CONTEMPLATED CHANGE NOTICE

CCN NO: **05 R1**
 CONTRACTOR: **Mr. Pat Newton**
Talco Building Innovations Inc.
 4728 Bank Street
 Ottawa ON K1T 3W7

PROJECT NAME: **225 Huntmar**
Ottawa, Ontario

PROJECT NO: 15-010
 DATE: 2020, April 04

DATE	PROJECT NUMBER	
SCALE		
NTS	15-010	
	PROJECT NAME Enterprise Rent A Car Kanata	
	DESCRIPTION REVISED KEY DROP	SK-13R1

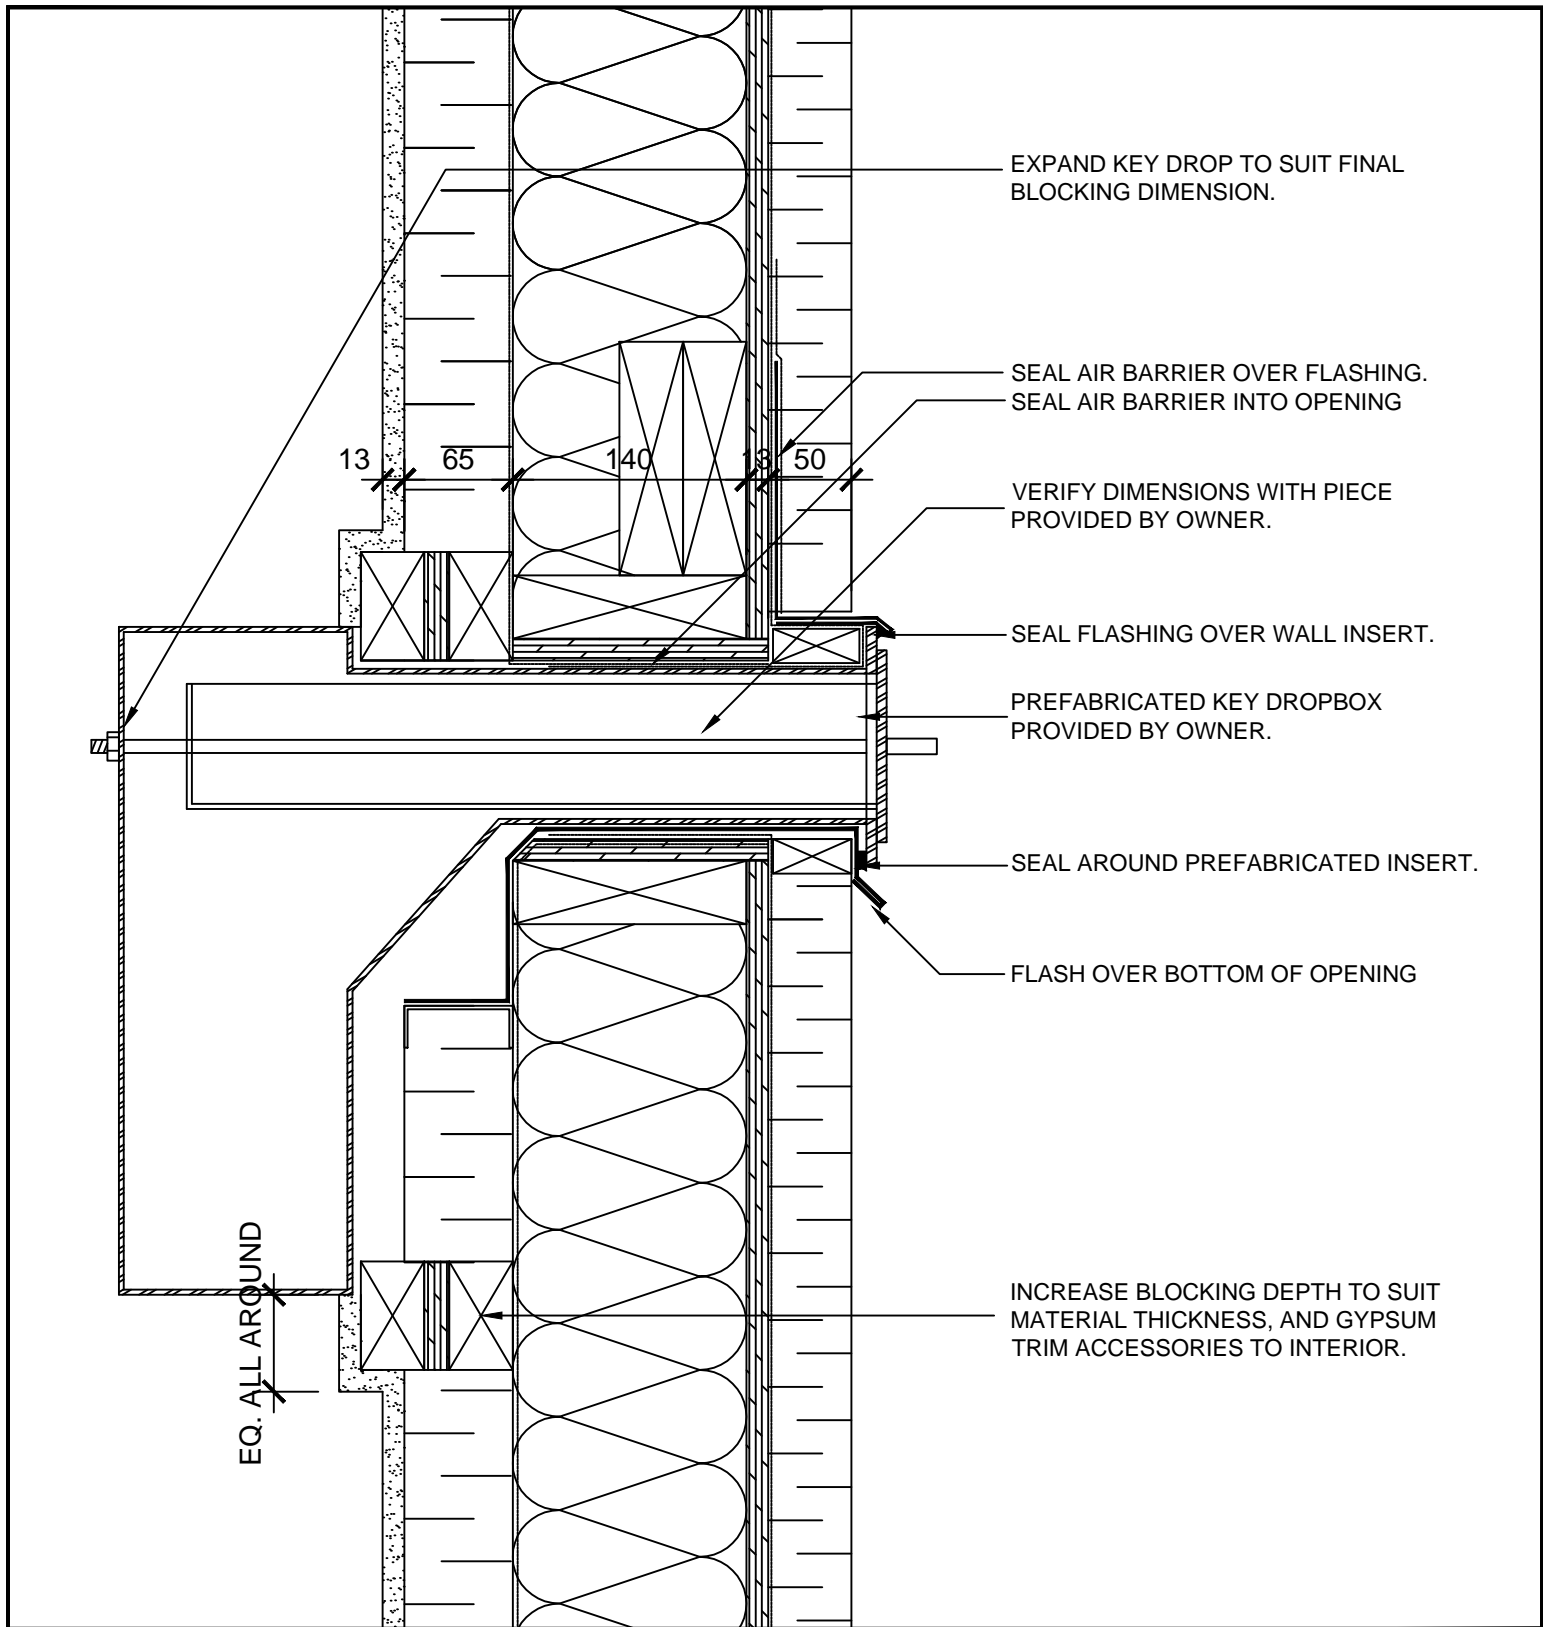
1. Refer to attached SK-13R1 regarding installation detail for key drop box provided by owner.
2. Refer to scanned stamped building permit drawings returned from the City of Ottawa, and accompanying letters. Provide proposed pricing to delete 50mm Rockwool Rockboard 40, and supply and install 64mm Rockwool Rockboard 40. Similarly provided proposed pricing to supply and install 65mm z bar furring where wall types previously noted 50mm z bar furring.
3. Insulation and wall composition values are to match the wall construction noted in the Rockwool insulation thermal modeling evaluation report.
